**TOWN OF PALM BEACH**  
Planning, Zoning & Building Department  
360 South County Road  
Palm Beach, FL 33480  
[www.townofpalmbeach.com](http://www.townofpalmbeach.com)

**PZ&B Staff Combination Memorandum: Landmarks Preservation Commission and Town Council**

**SUBJECT:** ZON-24-021 (COA-24-003) 800 SOUTH COUNTY RD (COMBO)

**MEETING:** JANUARY 17, 2024 LPC  
FEBRUARY 14, 2024 TOWN COUNCIL

**Proposed Bridge**

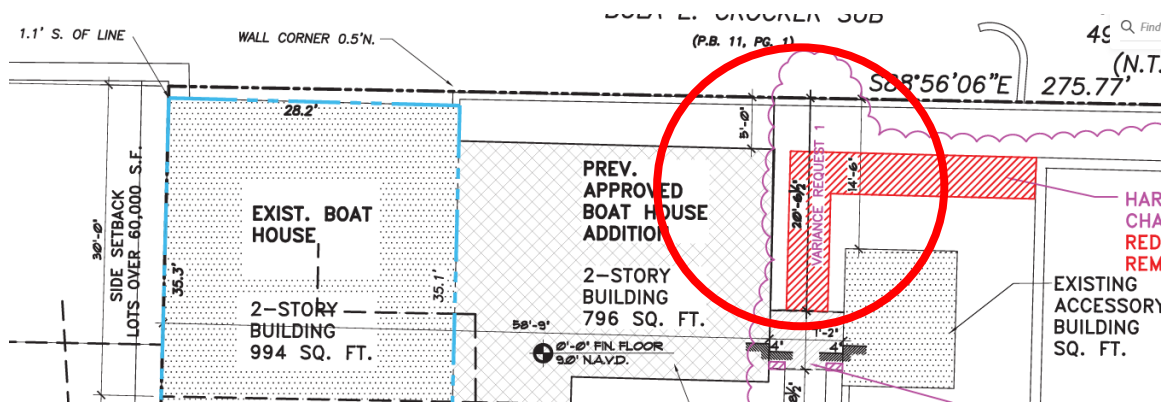
The applicant is seeking a Certificate of Appropriateness and a tax abatement amendment for exterior alterations to a landmarked property. Specifically, fenestration changes and the addition of an uncovered bridge connecting the boat house and generator building. The window and door changes are nominal and in keeping with the existing architectural style. The changes also appear to not adversely impact original elements of the buildings. The proposed bridge requires a variance for its side setback and lot coverage. However, it is only approximately 41 SF, could be removed

in the future and there is another bridge on site. The design of this bridge is simple and does not compete with other architectural elements on site.

As it pertains to VARIANCE 1, to reduce the required side (north) setback by 9.5' in order to construct the elevated walkway in between two detached structures with existing nonconforming setback. The existing landmarked building has a nonconforming north side setback which varies from 1.1' to 5' to 14.5'. This small 7'-2" wide bridge is a negligible element within a greater nonconformity.

As it pertains to VARIANCE 2, to further increase the nonconforming lot coverage. The 41 SF addition will increase the lot coverage by 0.07%. The lot coverage increase is triggered by the elevated walkway, ie bridge. This covered element counts towards the lot coverage. It must be

noted that the applicant has made effort in this area to increase the overall green space by removing some side walkways in this immediate area.
